**CARMICHAEL COAL PROJECT
GROUNDWATER FLOW MODEL
INDEPENDENT REVIEW
(RE: APPROVAL CONDITIONS 22 & 23)**

Prepared for	Adani Mining Pty Ltd	28 November 2014
--------------	-----------------------------	------------------

This report summarises the outcomes of an independent peer review by Hugh Middlemis of the Carmichael Coal Project numerical groundwater flow model developed by GHD for Adani Mining, consistent with the requirements of the Commonwealth approval Conditions 22 and 23 (EPBC 2010/5736).

Figure 1 - Carmichael Coal conceptual groundwater model (after GHD, 2014)

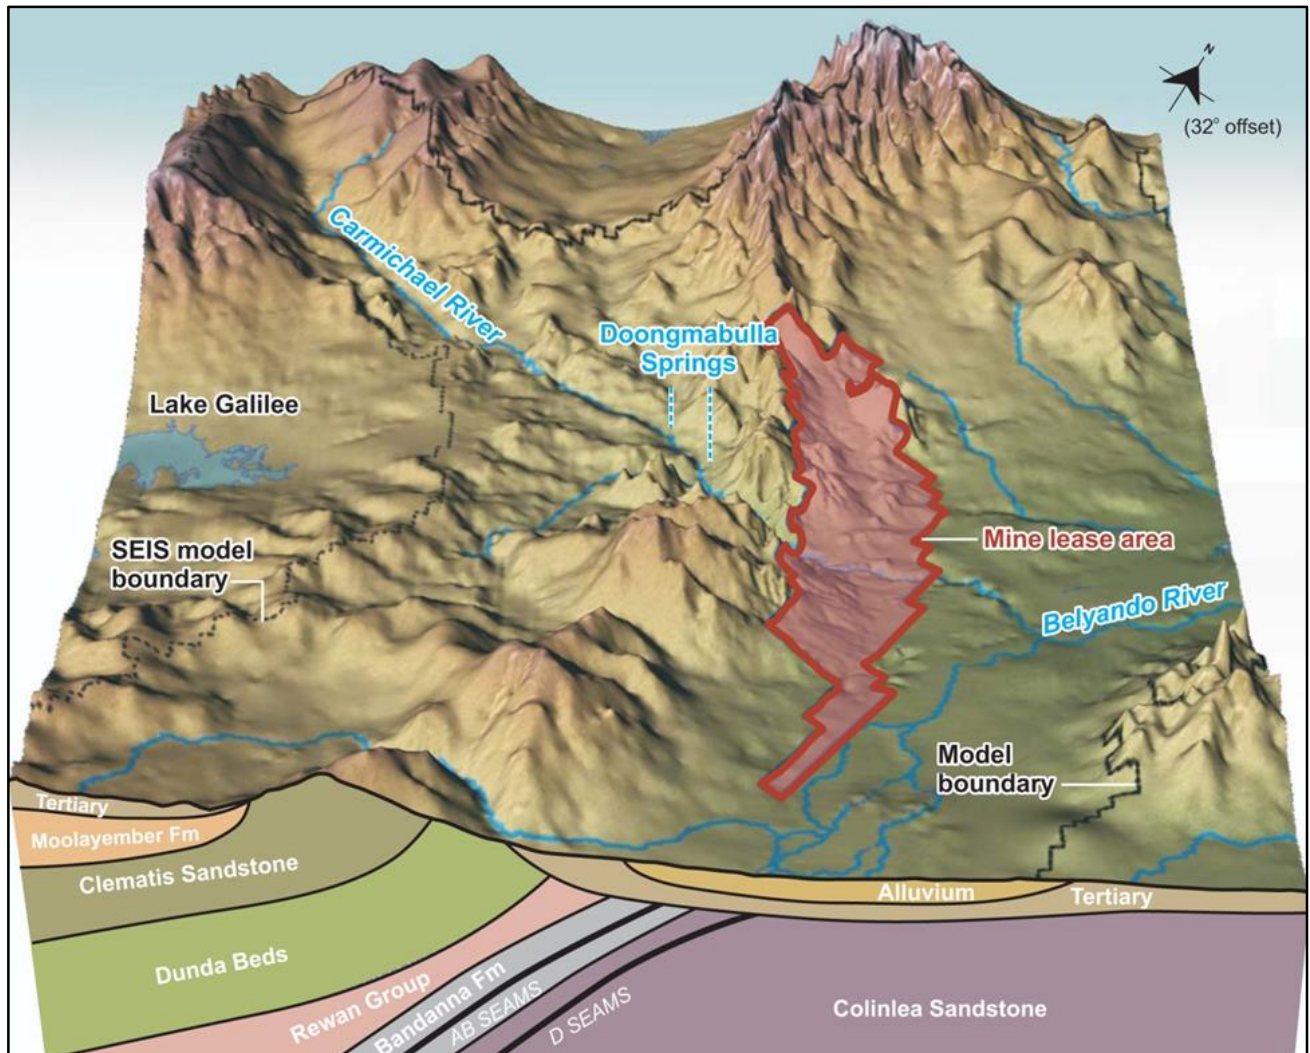
In the north-west corner, inflow is apparent from the central topographically high areas (see also Figure 1), which then largely short-circuits to outflow to the north-western boundary. It is not completely clear whether this is an accurate reflection of the flow system in this local area (data is sparse), but these conditions do not have a major effect on the gradients or levels in the main central-western part of the model. As implemented, they largely represent a local to semi-regional scale flow system that has little bearing on the main flow system under consideration and the predicted impacts (which do not extend far beyond the mine lease areas in the

Condition 23(a)(i) required the relocation of the western GHB to the western edge of the model domain (from the previous EIS/SEIS model alignment with the topographic divide east of Lake Galilee – see dashed line in Figure 1), along with review and revision of the GHB conductance parameter and cell elevations. This essentially forms an alternative conceptualisation approach that substantially helps to address uncertainty (i.e. consistent with best practice: Barnett et al, 2012; section 3.4).

Figure 2 – Carmichael conceptual model west-east section (after GHD, 2014)

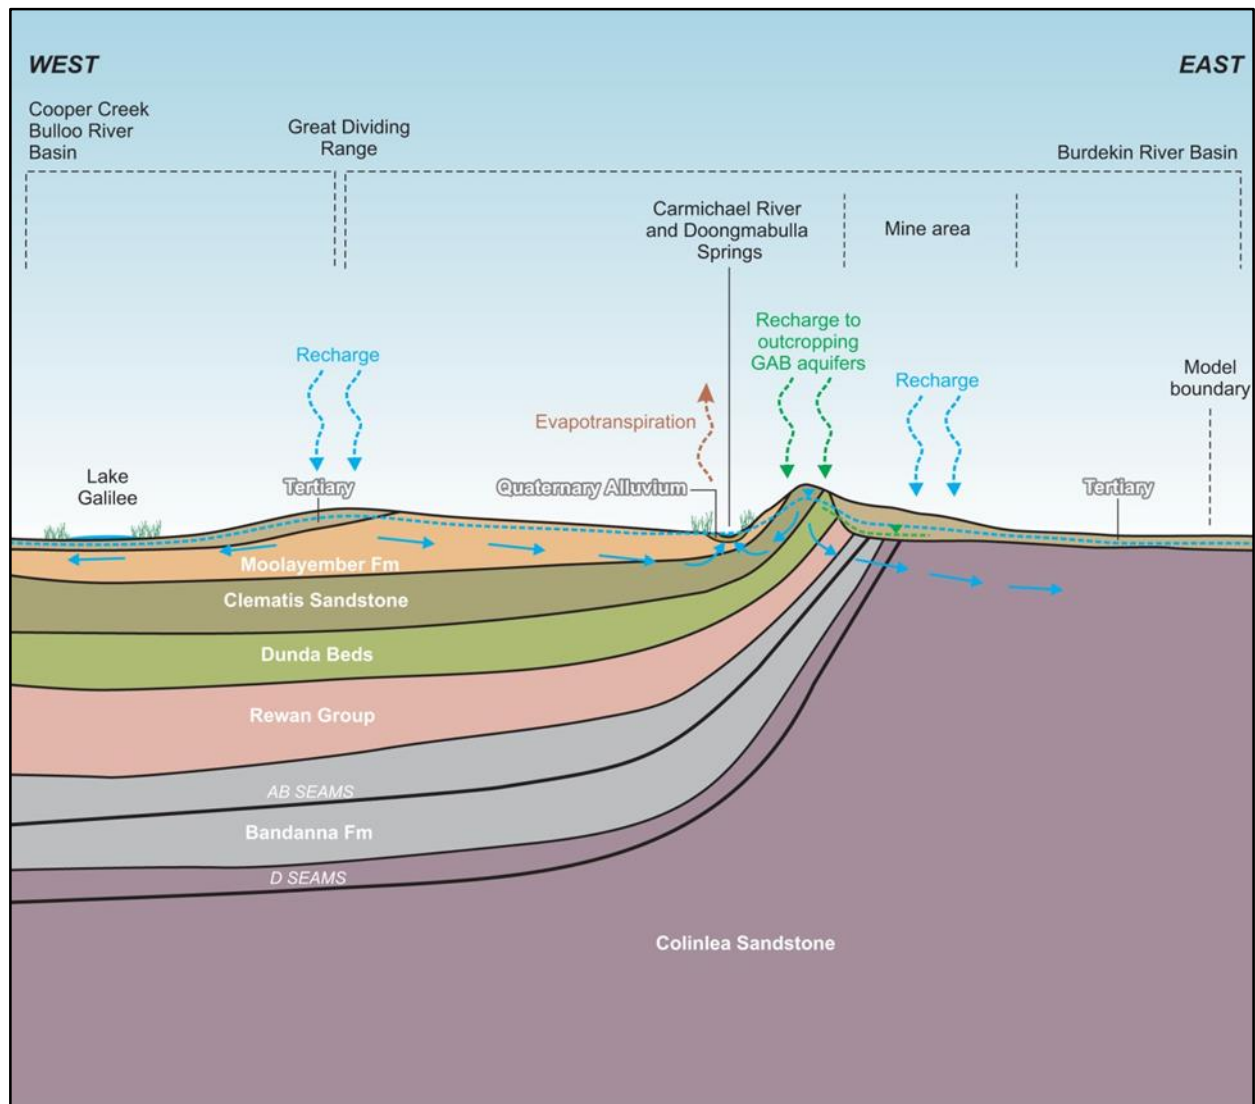
4. Is the conceptual model based on all available data, presented clearly and reviewed by an appropriate reviewer?	Yes	<p>A multi-disciplinary team from GHD has been involved in the hydrogeological data analysis and review, in consultation with DNRM hydrogeologists on key elements (mostly hydrogeological structure & parameter values). Additional data was obtained to inform the 2014 western boundary revisions, and the model layer structure, properties and boundary conditions have been reviewed (with inputs from DNRM staff). Good presentation of conceptual model in 2014 report (e.g. Figure 2 herein).</p>

Figure 3 – Geological section, mine areas and free-draining fractured zone

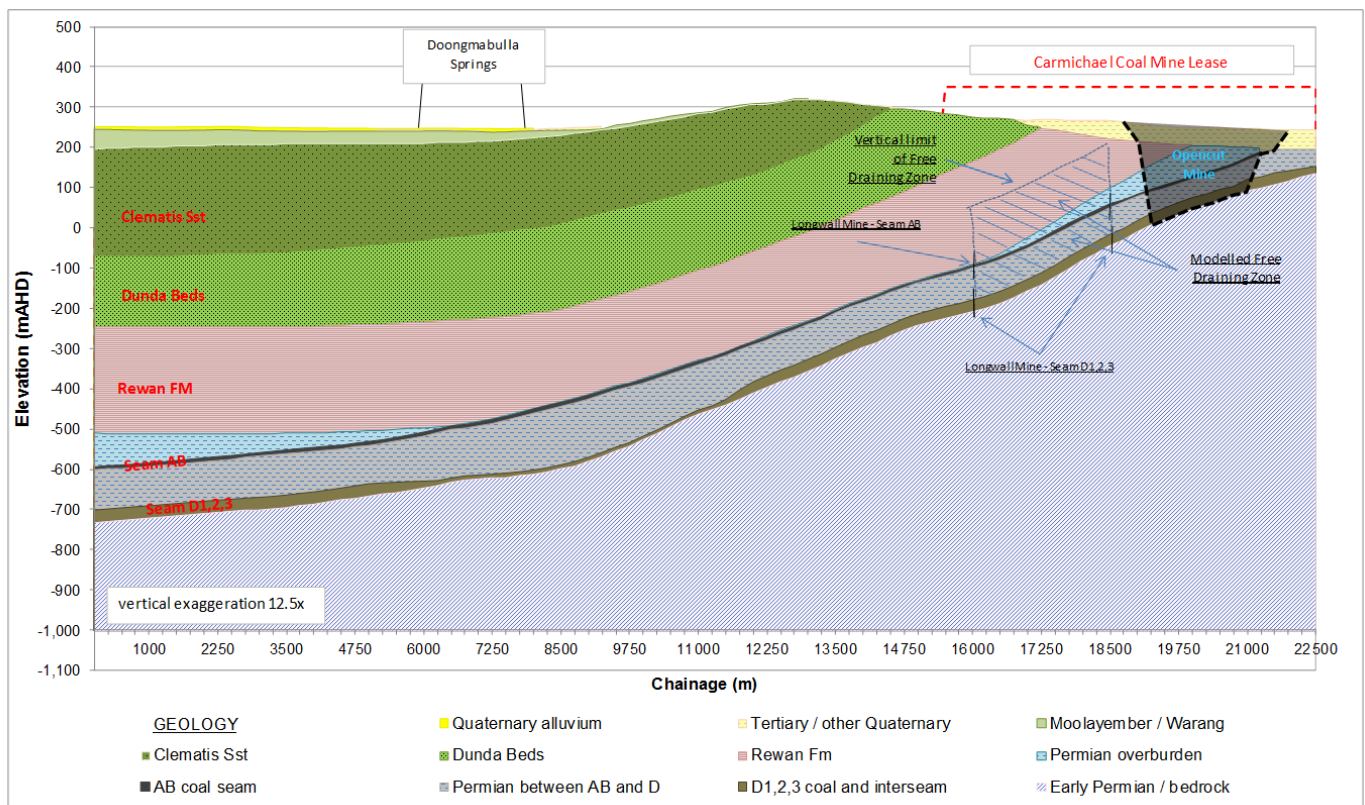
Additional parameter changes were made to the vertical hydraulic conductivity (Kv) values to represent a 150 metre thick free-draining fractured zone above the underground (SEIS, section 5.6.3; see also Figure 3 below, after GHD, 2014).

A factor of 50 was applied to the lower zone Kv and a factor of 10 was applied to the upper zone Kv. The zone extends through the overburden (layer 8) and up into the Rewan (layer 7). I note that the model reports cite research by Guo et al (2007) as the basis for fractured zone parameter assumptions. Guo et al (2007) was also used as the basis for research by Tammetta (2013) that is cited in Ditton and Merrick (2014) and has recently been shown to comprise conservatively high parameter values (i.e. it could be argued that the fractured zone assumptions that have been applied also include an allowance for non-mining fracturing of the Rewan). The runs carried out with and without this free draining fractured zone indicate that drainage through the Rewan increased by less than 4% (due to the free draining fractured zone), indicating low uncertainty on the potential effect of Rewan faulting/fracturing.
